# WELLINGTON CITY COUNCIL

## **Proposed Plan Change 83**

Kiwi Point Quarry

### **s42A Report – Appendix 5**

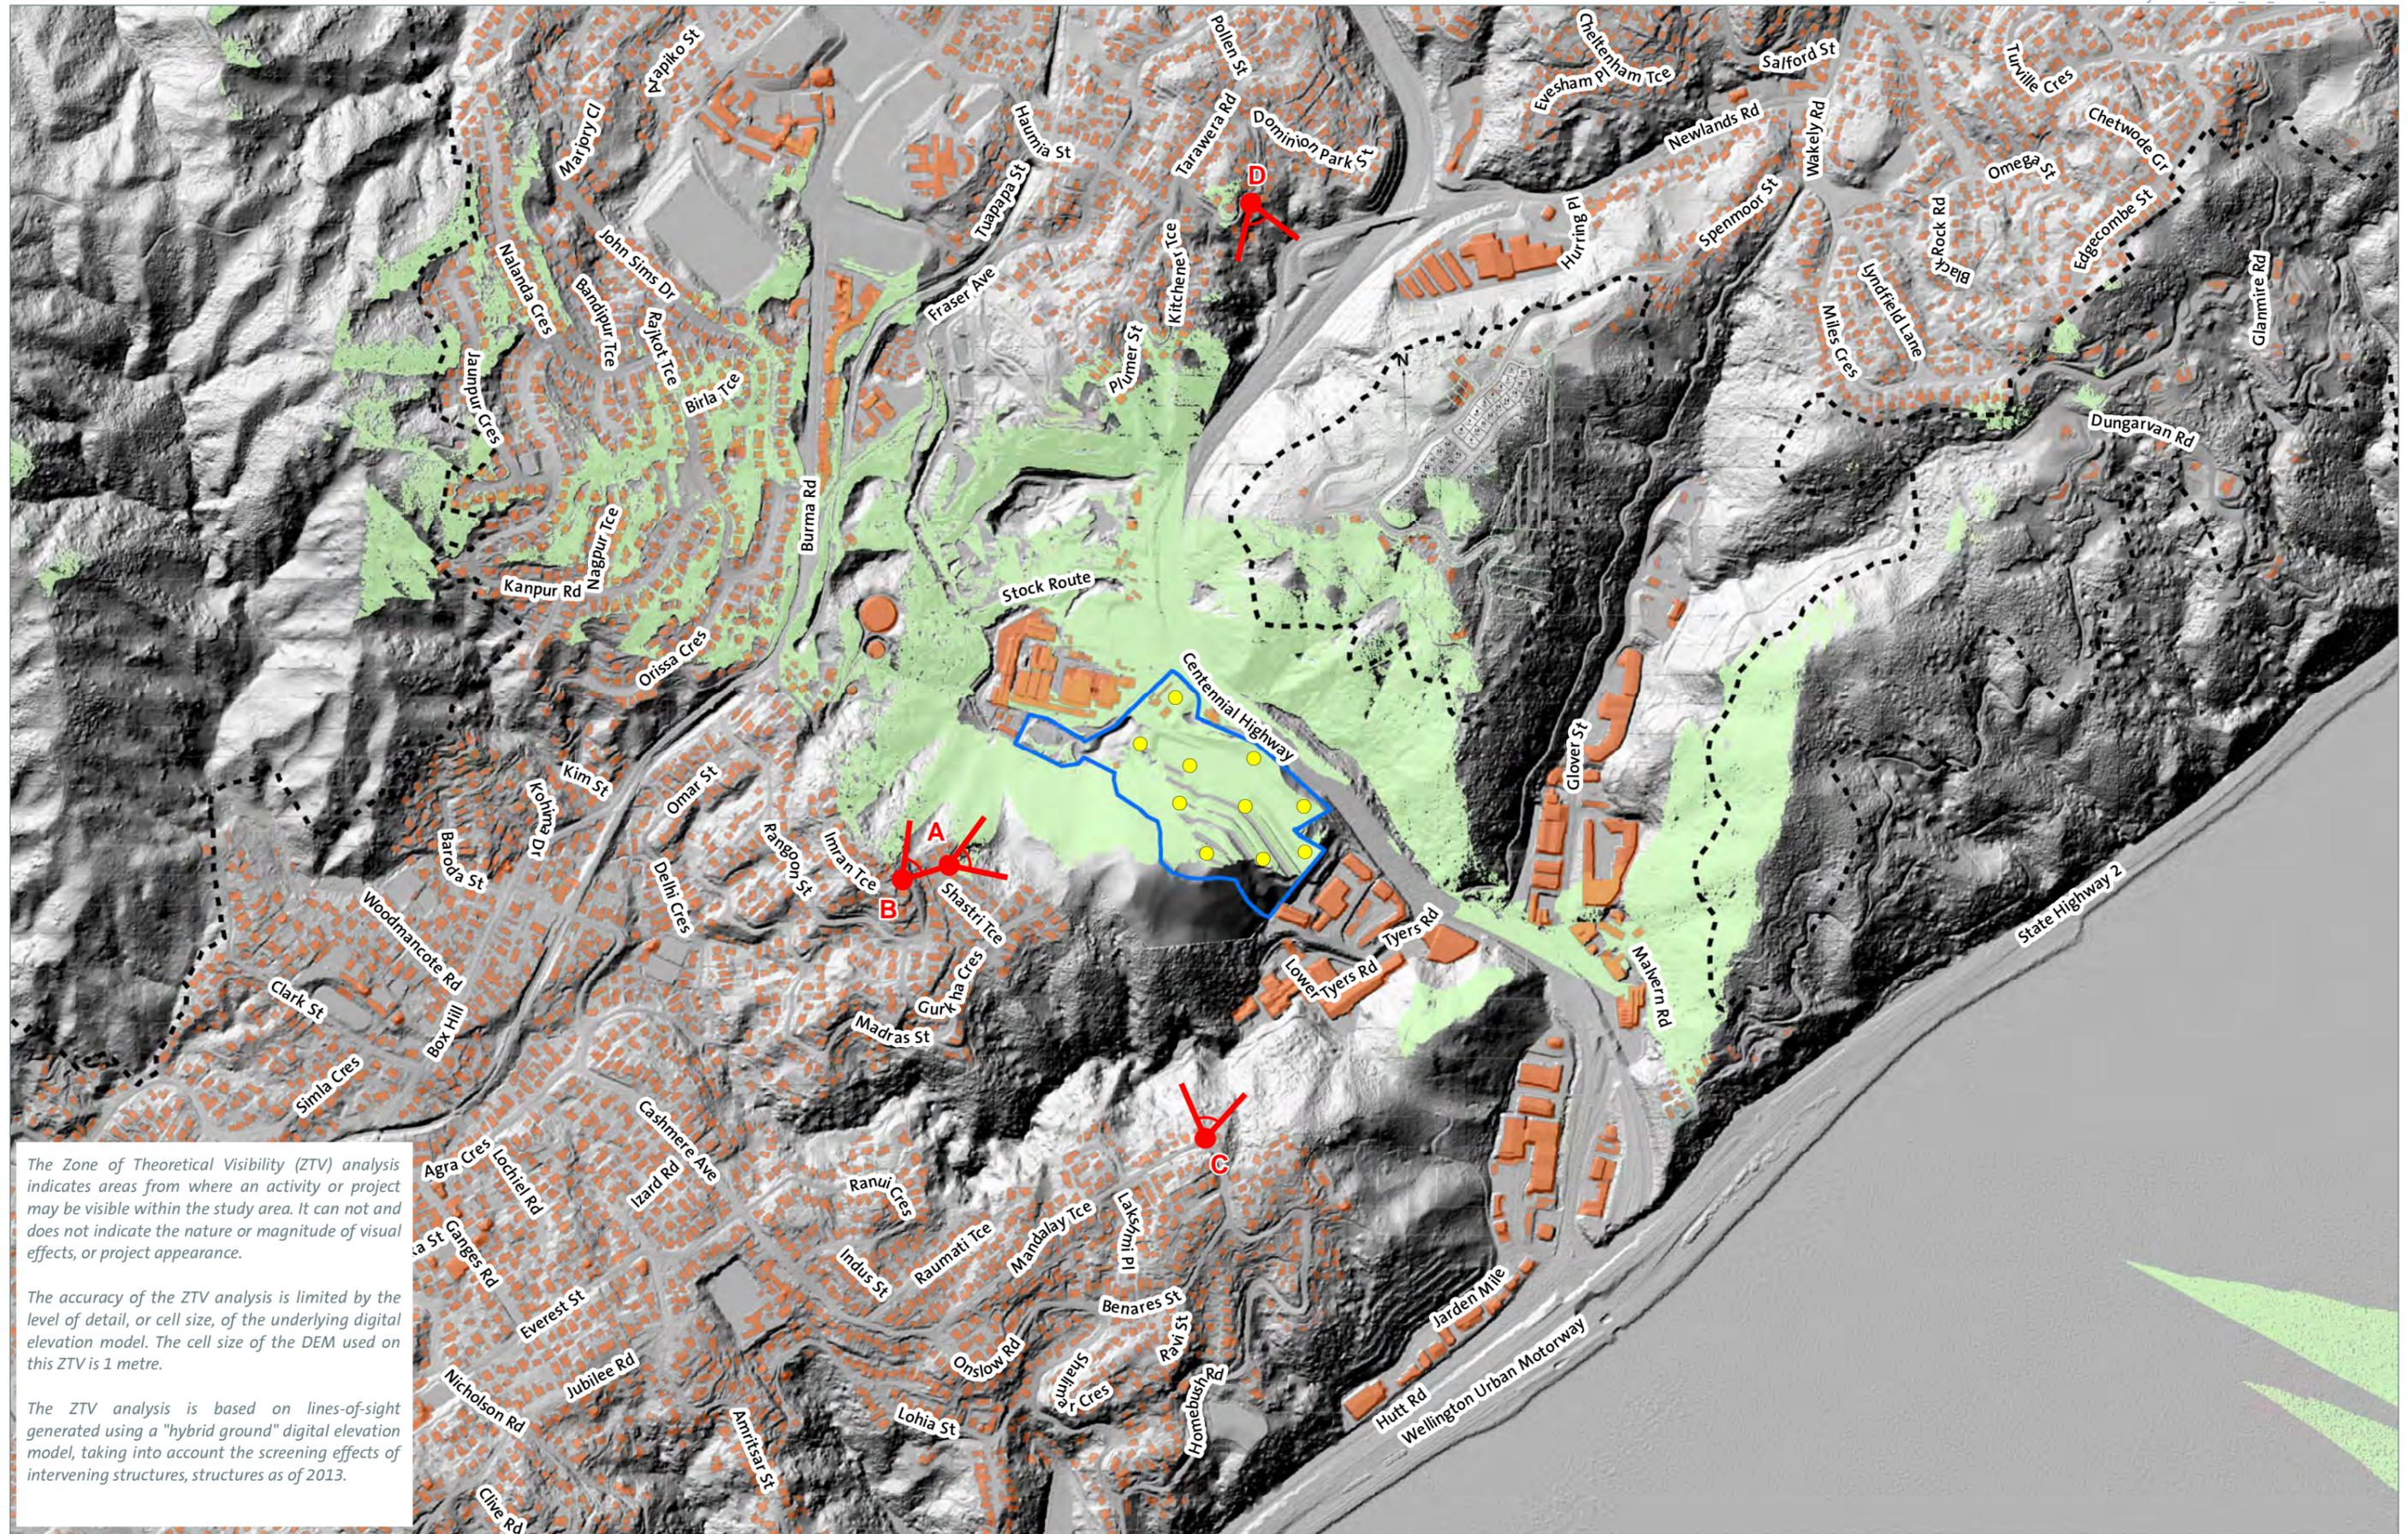
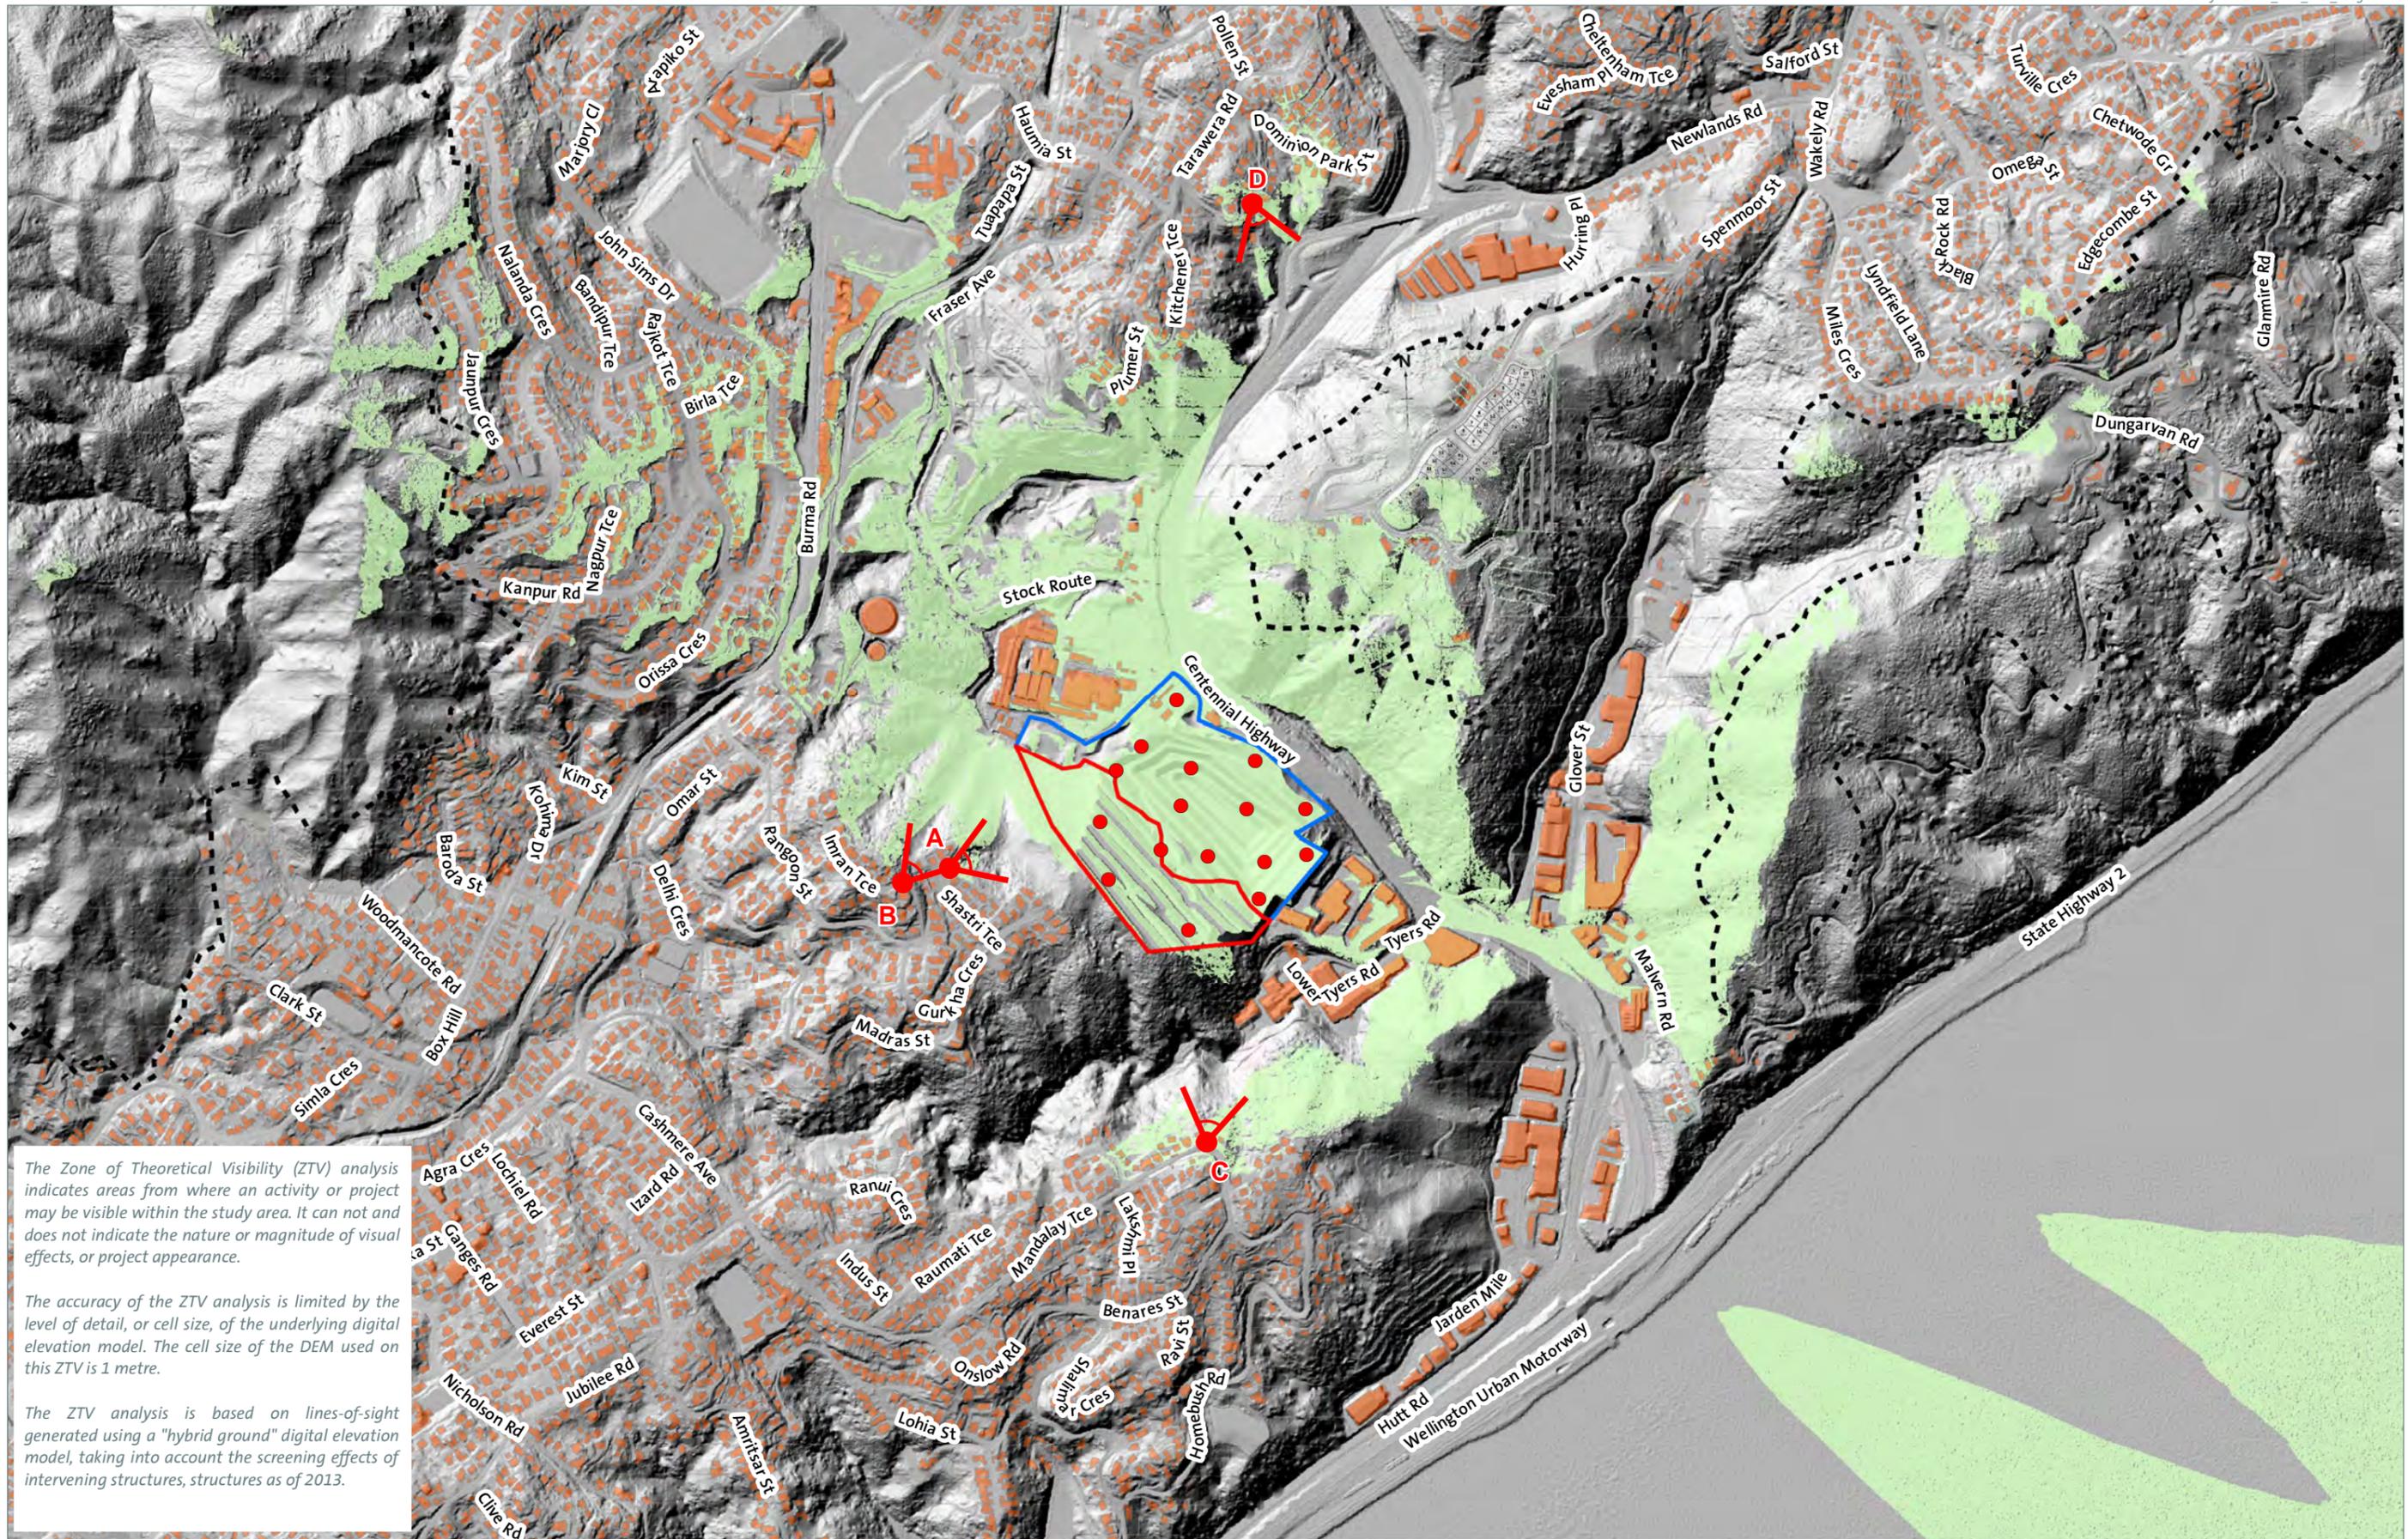
- 3.61. To assist with understanding the change in view, two ZTV maps have been prepared, based upon the digital 3D model provided by Isthmus Group.<sup>9</sup> These maps illustrate the potential viewshed of the permitted development (Option 3) compared with the proposed Plan Change (Option 4).

- 3.64. The currently permitted development is based upon 10 observable points located on the face of the working area. The proposed plan change ZTV is based upon the same 10 observable location points, relative to the proposed working levels at their maximum extent, together with six additional points representing the proposed extension of the working area. These points give an indication of location from which the working area of both options is likely to be able to be seen. Site visits were also carried out to verify the findings of the ZTV. These confirmed that extended views of the proposed development will be potentially available from many residential properties.

- 3.66. The ZTV illustrating the Plan Change proposal illustrates that the viewshed of the proposal is extended to the south, with the removal of the spur to the west of Ghurka Crescent opening up views into the quarry and out towards the harbour. This additional area of visibility covers at least 18 properties to the south of the site, on Homebush Road, Mandalay Terrace and Narbada Terrace in Khandallah, in the location of Submitter 36.

- 3.69. The ZTV and photographs illustrate that the proposed plan change will be visible from a wider residential audience than the permitted development. The removal of the spur above Tyers Stream will open up views into the working area of the quarry from areas to the south, and views of the upper face of the quarry for viewers to the northeast. While the visual simulations provided in the application are well executed in terms of depicting the proposed extent of the quarry benches in Option 4, they underplay the level of landscape and visual effects in relation to the broader landscape context. That is, the extent of the viewshed and the size of the potential viewing audience is not sufficiently described, analysed and depicted as I have described above and illustrated in Attachment 4.
